ZENITH RADIO CORP.

MODEL 4G800  
Chassis 4E41

### Zenith 4G800 Chassis 4E41

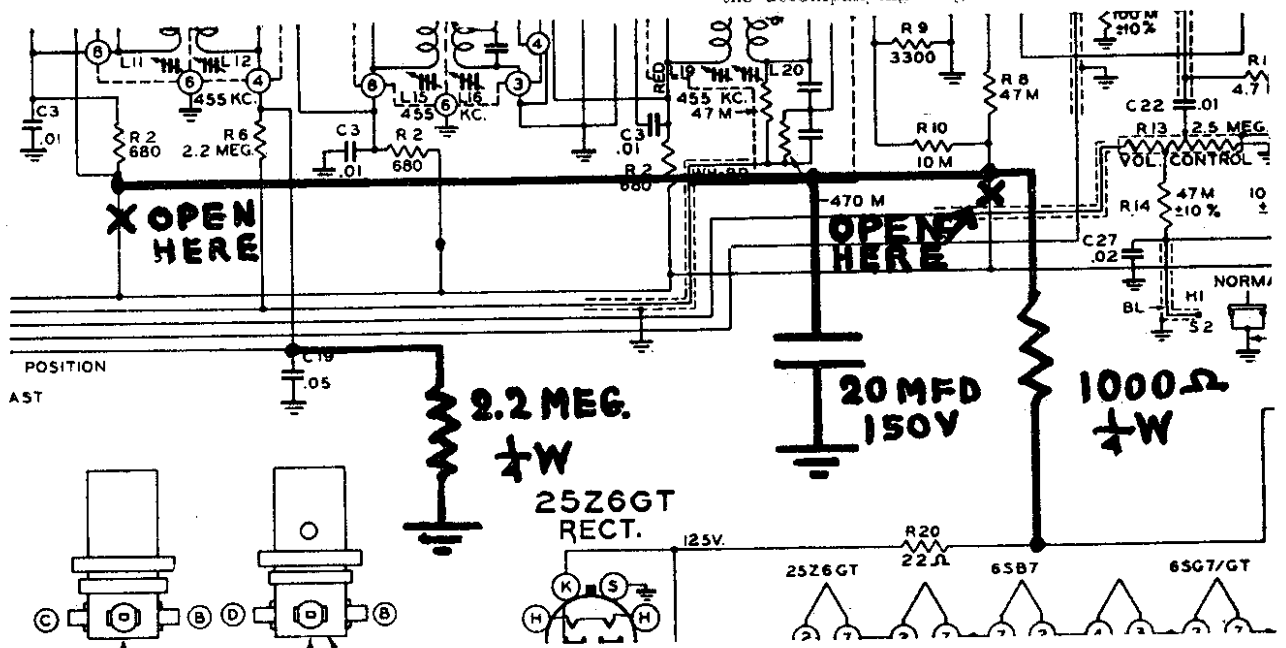
Enough extra lead length should be left when replacing the wavemagnet lead on the Zenith 4G800 so that a break does not occur at the point indicated.

In some cases when the front lid of the receiver is open, the receiver will cut in and out or sometimes be entirely dead. The wire from the wavemagnet to the front door hinge may break at the hinge connection. To correct this condition, remove the handle and resolder these leads, being quite certain that solder is not allowed to run back on the antenna lead and that enough extra antenna lead is allowed for flexing to prevent breakage when the door is open as illustrated in the accompanying diagram.
